## WYOMING STATE PENITENTIARY Independent Peer Review Study

### **Final Report**

WJE No. 2017.3123

### **Members, Joint Appropriations Committee**

## Exhibit I-3: Comparison of Relative Elevations Around Perimeter of Gymnasium in the South Facility

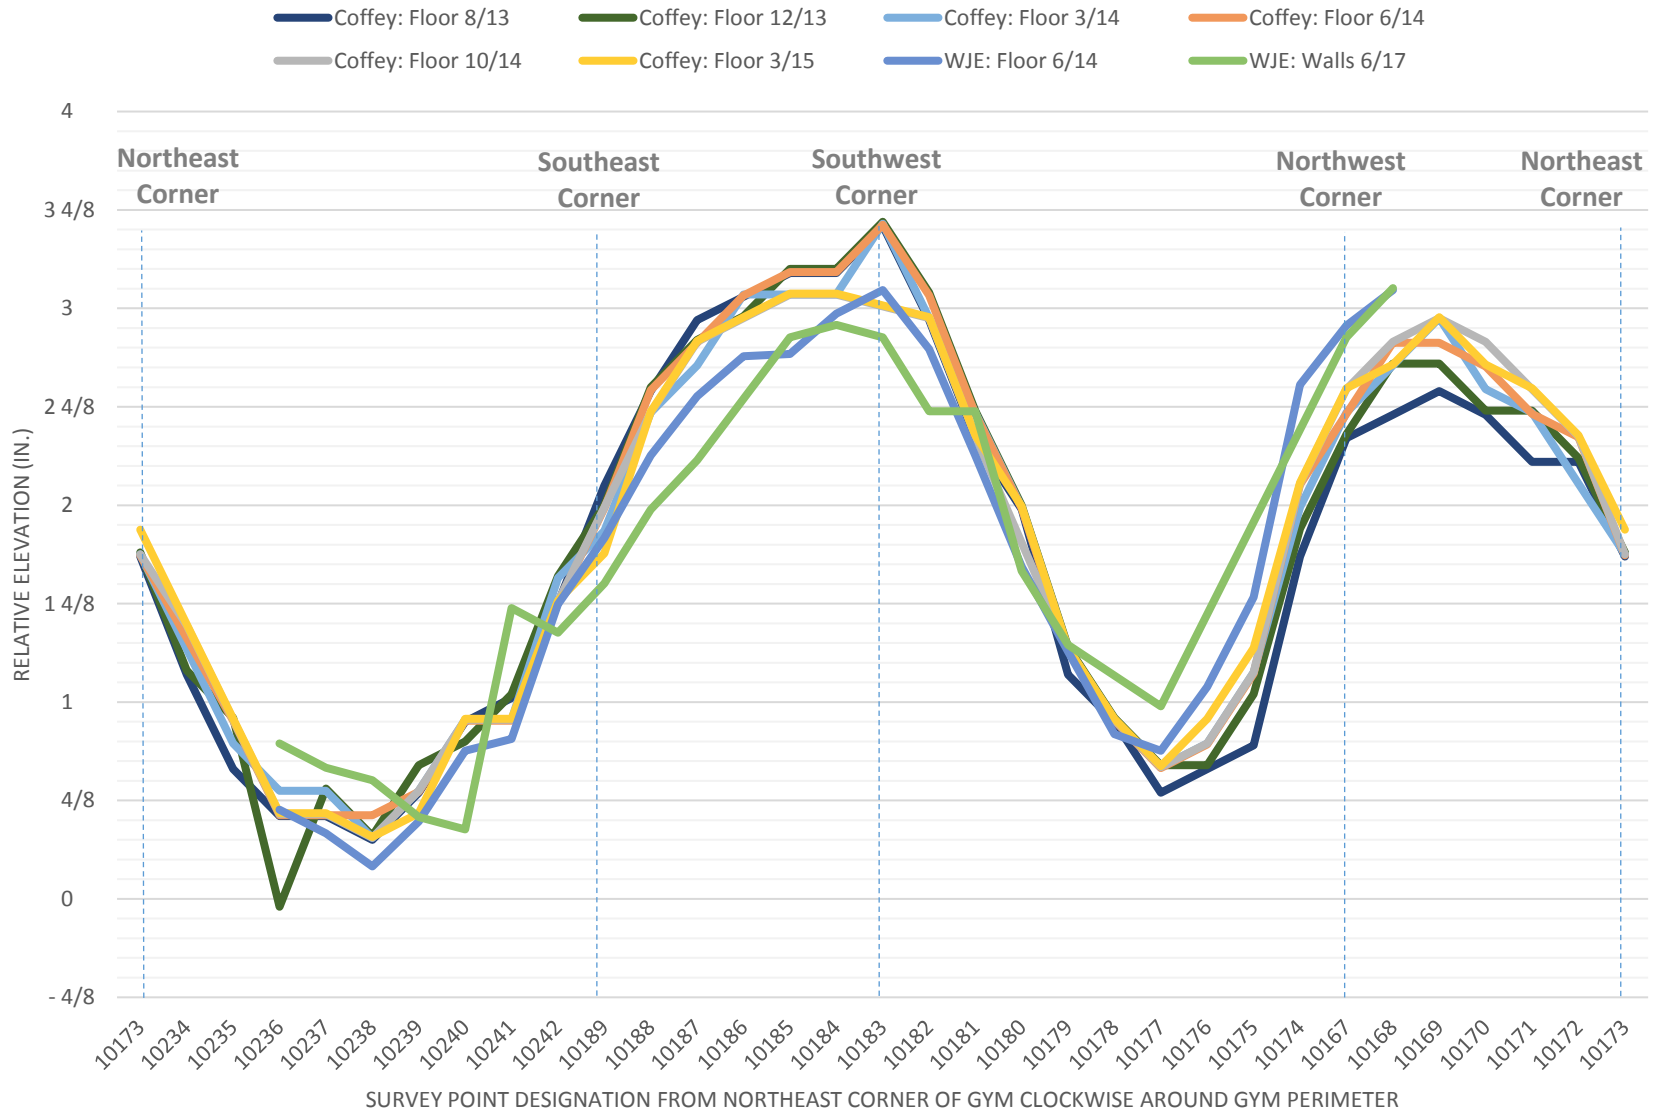
When the questionable data was removed from consideration, good correlation between Coffey and WJE’s surveys was obtained. In many locations, the comparisons fell within reasonable survey tolerance, which we estimate to be +/- 1/4 inch to +/- 1/2 inch considering the difficulties of this particular survey and the equipment used by Coffey. Where the measured changes fall within those ranges, ongoing movement is unlikely, but cannot be ruled out based on the survey data alone. In other locations, such as the Hobby Room (now the Cardio Room), Gymnasium, East Hall (i.e. north-south corridor between Areas E and F), and the North Hall along the Gymnasium (i.e. east-west corridor between Areas D and E/F), the data indicates that modest movements have likely occurred since August 2013. Exhibits I-1 and I-2 in Appendix I provide a topographic comparison of the relative floor elevation results from Coffey’s August 2013 and WJE’s June 2017 surveys in the gymnasium.

Exhibits I-4 and I-5 provide a graphic comparison of the relative elevation results of the wall measurements in the Northwest Corridor from Coffey’s August 2013 and WJE’s June 2017 surveys, respectively. WJE’s June 2017 floor elevation survey results are illustrated in Exhibit I-6. A comparison of survey results between portions of the structurally supported corridor masonry walls and the immediately adjacent slabs-on-ground reveal similar consistencies, as indicated in Exhibit I-7.
